*Nomad*

SERVICE BULLETIN

SUBJECT: RATING OF AC SYNCHRO FUSE FOR ADF 1 (CUSTOMER OPTION G74)
CHANGED FROM 0.5 AMP TO 1.0 AMP (MODIFICATION N286)

Rework on AC Distribution Box
Figure 1

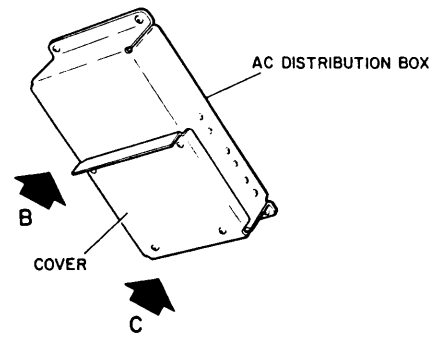
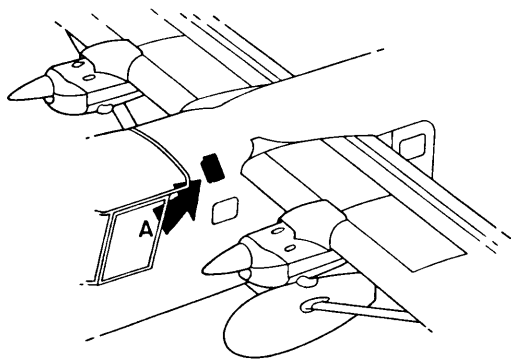
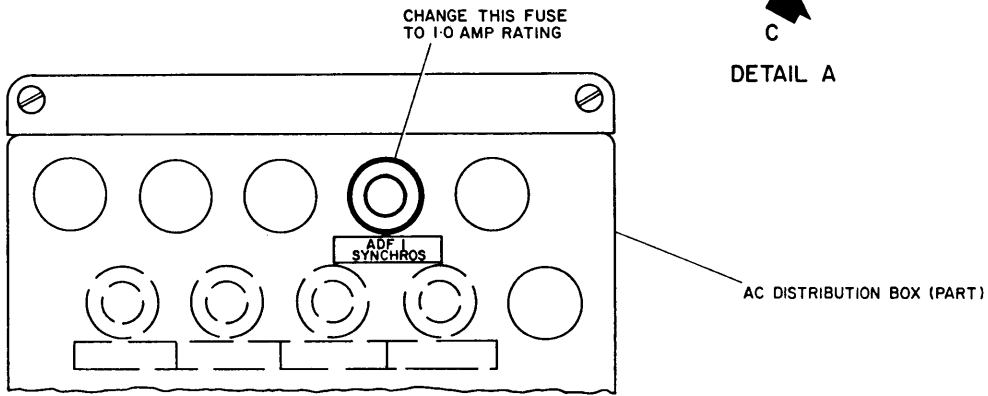
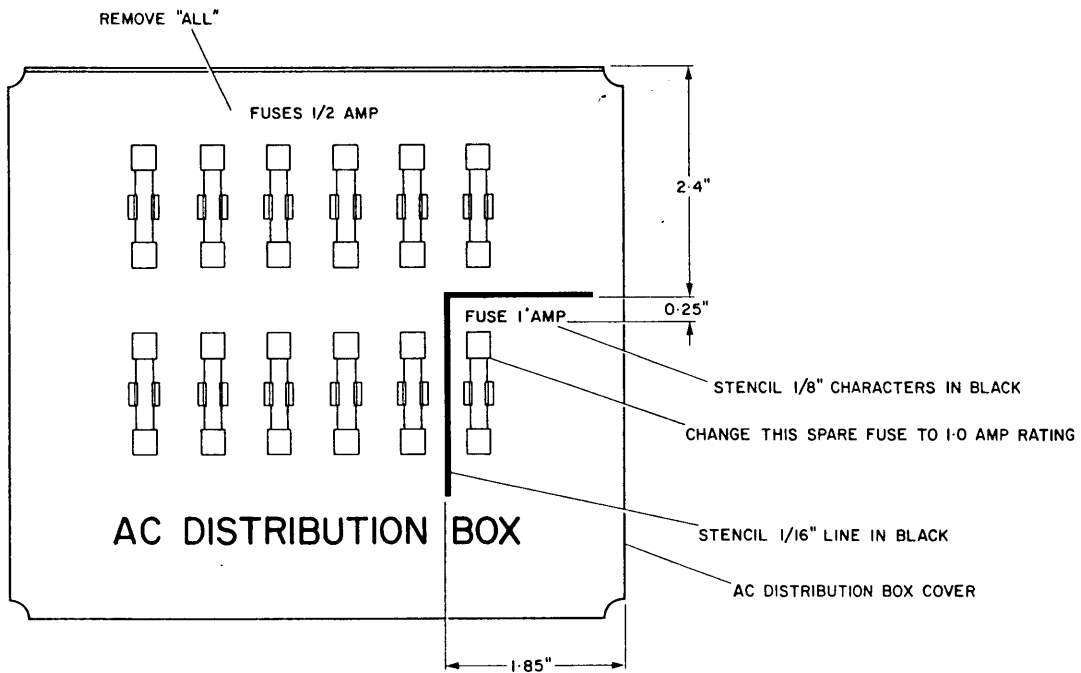
The 0.5-amp fuse fitted in the ADF 1 position in the AC distribution box is changed to a 1.0-amp fuse. A spare 1.0-amp fuse is fitted to the distribution box cover.

- A. Remove and discard the 0.5-amp fuse fitted in the ADF 1 SYNCHROS position on the AC distribution box (Ref Figure 1) and replace with a 1.0-amp fuse P/N F02A250-1A.
- B. Remove and retain the spare 0.5-amp fuse P/N F02A250-1/2A from the bottom RH corner of the AC distribution box cover (Ref Figure 1, Detail C) and replace with a 1.0-amp fuse P/N F02A250-1A.
- C. Remove the word ALL from the stencilled annotation ALL FUSES 1/2 AMP at the top of the AC distribution box cover.
- D. Stencil a demarcation line and the words FUSE 1 AMP on the distribution box cover as shown in Figure 1, Detail C.
- E. Alter the part number of the distribution box cover from 1B/N-81-269 to 1A/N-81-431.
